Technical Advisory Bulletin (TAB)

Bulletin #: TBBEE1614A

Product: BERNINA E16

Subject: Needle 16 dropping

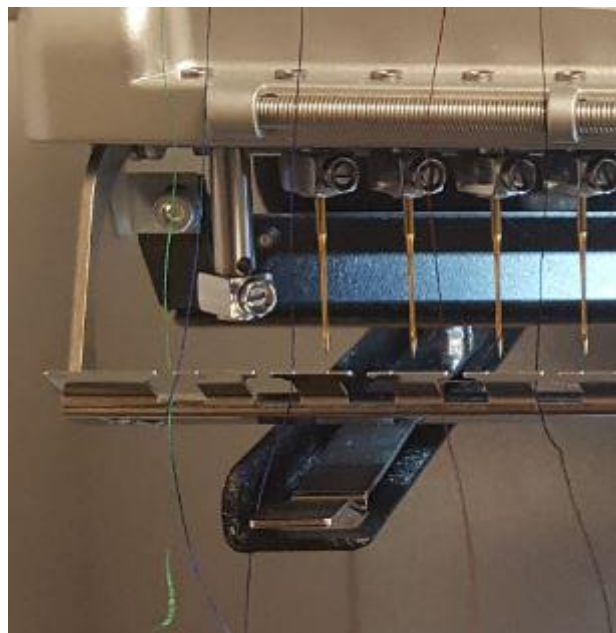
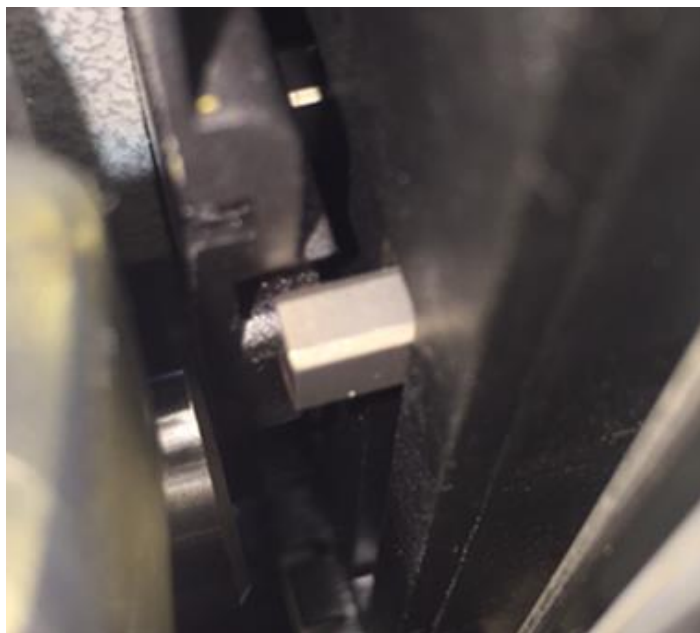
When the Needle Case reaches this far left position, the Needle Bar Stud on Needle #16 is positioned very close to the left end of the guide channel in the Left Front Upper Arm Cover, or even protrude out of this channel. See picture below.

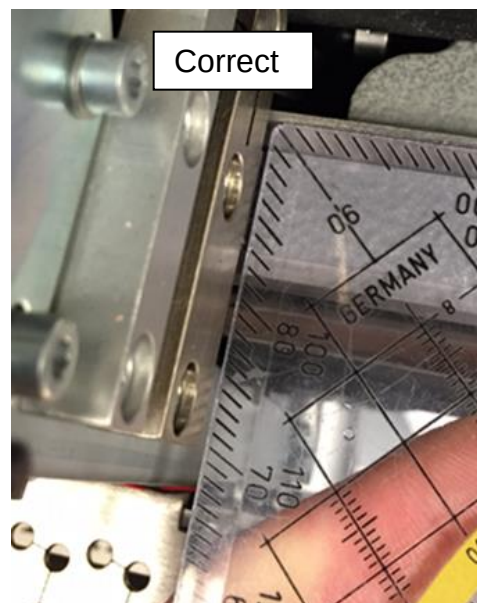
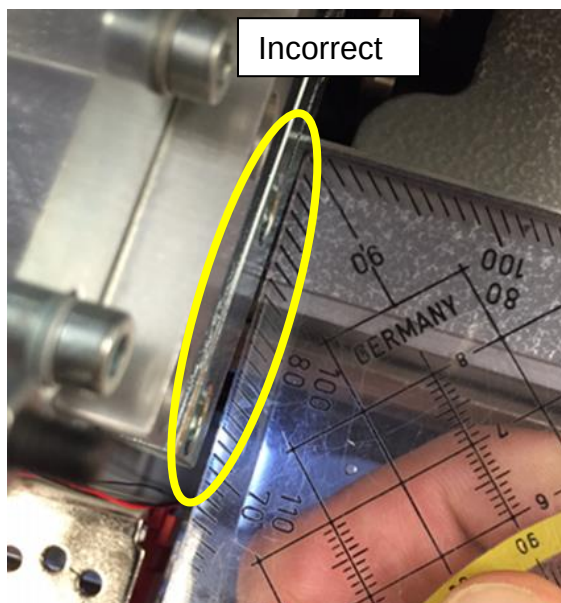
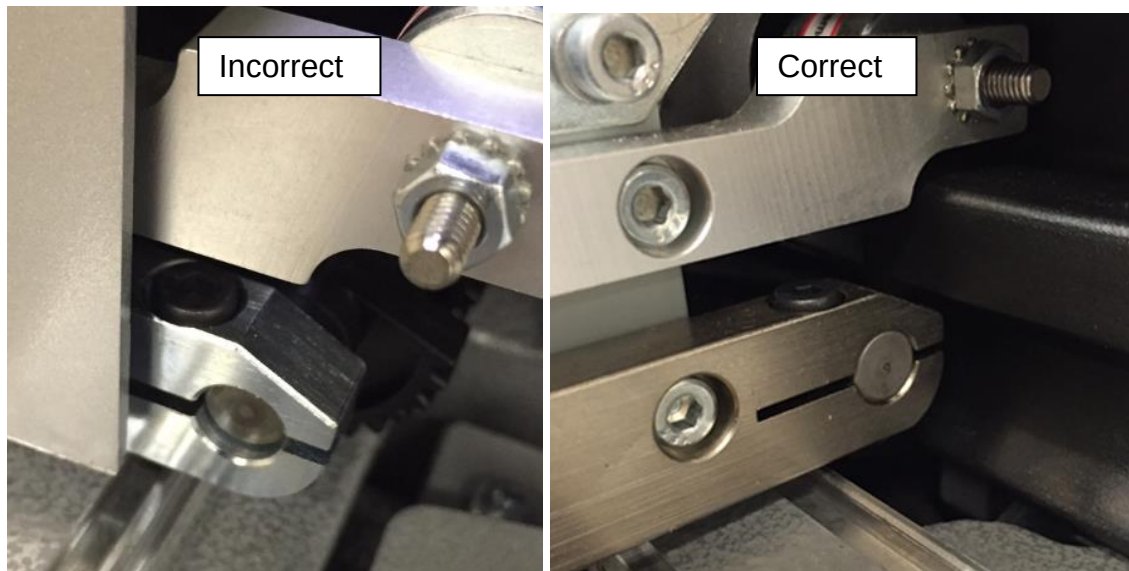
4. For machines still in BoA stock, measure the distance the number 16 Needle Bar Stud protrudes beyond the left side of the Left Upper Arm Front Cover. If the measurement is more than 2.5mm, it is recommended that the Needle Case Assembly be re-adjusted to reduce this distance. Only BERNINA trained technicians are recommended to perform this readjustment.

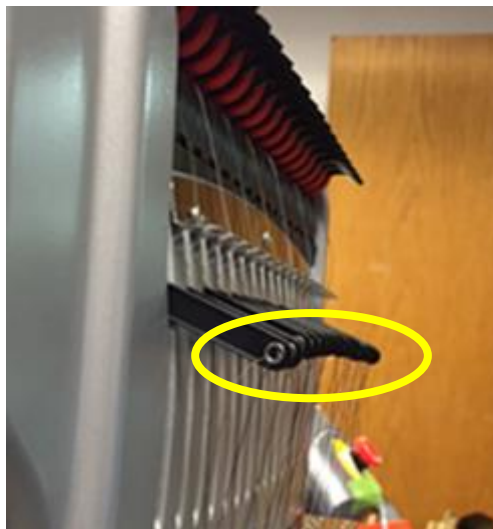
5. **Technicians Only:** The cause for this issue is mostly the result of the Take-Up Lever Mounting Bracket on the right side of the Needle Case Assembly not being square or perpendicular to the Upper Head Casting. The right side of the Needle Case Frame is bent outwards and the Take-Up Lever Shaft is recessed as shown in the pictures below.

This issue can also cause the Take-Up Levers to be on an arc rather than straight line. Actually, if a machine shows the Take-Up Lever Arms to be on a pronounced upward facing arc then this is a good indicator that the Needle Case had been misadjusted.

During the process of correcting this issue the Take-Up Levers, Color Change and Thread Feed assemblies will all require readjustment to machine specifications.
